# Service Bulletin

Bulletin No.: PI1232

**Subject:** Rattle Noise on Right Front Cross Rail

**Models:** 2015 Cadillac Escalade Models  
2015 Chevrolet Suburban, Tahoe  
2015 GMC Yukon Models  
Equipped with Accessory Cross Rails (RPO VQQ)  
Vehicles Built Prior to April 4, 2014

3824999

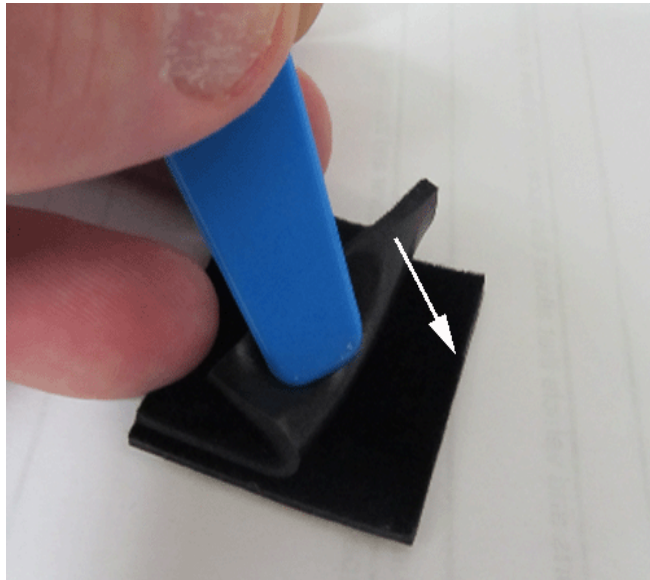
**Important:** DO NOT remove or tighten the shoulder bolts (2) that connect the end caps (1) to the cross bow, as shown in the illustration above, as this will cause them to rattle when installed on the vehicle.
